Well Name: BIG BUCKS FED COM	Well Location: T21S / R32E / SEC 1 / SESE / 32.5010392 / -103.6213522	County or Parish/State: LEA / NM
Well Number: 501H	Type of Well: OIL WELL	Allottee or Tribe Name:
Lease Number: NMNM092187, NMNM92187	Unit or CA Name:	Unit or CA Number:
US Well Number: 3002547064	Well Status: Approved Application for Permit to Drill	Operator: ASCENT ENERGY LLC

Notice of Intent

Type of Submission: Notice of Intent	Type of Action Other
Date Sundry Submitted: 03/24/2021	Time Sundry Submitted: 11:44
Date proposed operation will begin: 04/01/2021	
<p>Procedure Description: Ascent Energy respectfully requests approval to revise the proposed BOP from a 5M BOP to a 2M BOP for the Big Bucks Fed Com 501H from beneath the base of the 20" surface shoe to setting the 1st Intermediate casing string only (13 3/8"). This revision is requested to accommodate the increase in the previously mentioned 1st Intermediate casing diameter of that string. Please see attached document for BOP schematic and sundry request specifics.</p>

Updated COA for the Sundry

2M ANNULAR BOPE & DIAGRAM

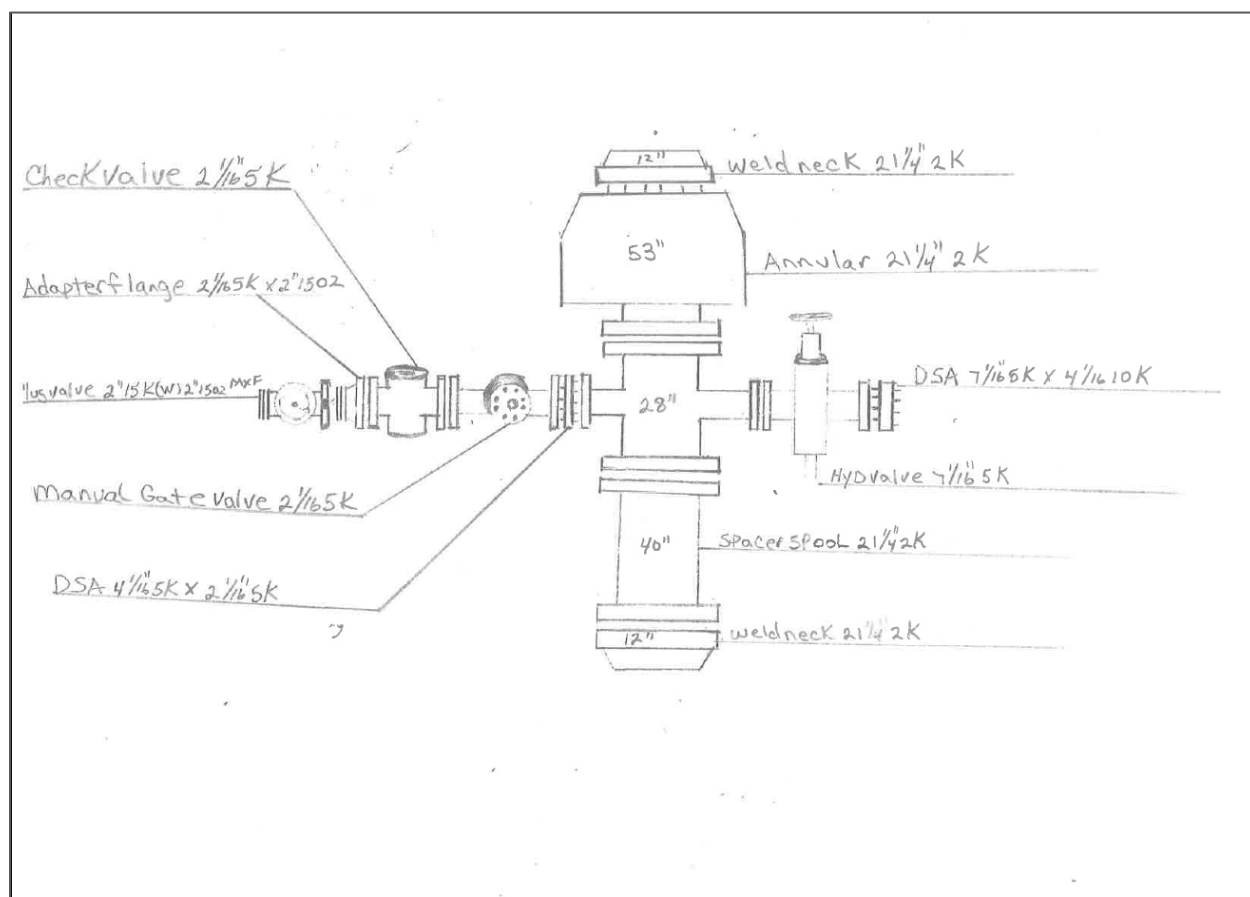
Ascent Energy respectfully requests approval to revise the proposed BOP for the Big Bucks Fed Com 501H from beneath the base of the 20" surface shoe to setting the 1st Intermediate casing string only (13 3/8"). This revision is requested to accommodate the increase in the previously mentioned 1st Intermediate casing diameter of that string.

From the Base of the 20" Surface pipe, the well will be equipped with a 2M Annular system. Before drilling out the 20" surface pipe, the 2M system will be tested to 250psi low and 1000psi high by an 3^d party service company. The 2M BOPE and related equipment will meet or exceed the requirements of a 2M psi system as set forth in On Shore Order No. 2 while drilling below the 20" surface shoe and to TD of Intermediate #1 (13-3/8" Casing). Once the Intermediate #1 13-3/8" Casing is cemented the 20" 2M BOPE and 21-1/4" wellhead will be removed and a 13-5/8" Multi-bowl wellhead and previously permitted 13-5/8" 5M BOPE will be installed. From the base of the Intermediate #1 13-3/8" casing string through running of the 5-1/2" production string the 5M BOPE will be equipped.

The previously permitted 5M choke will be utilized in conjunction with the 2M Annular System.
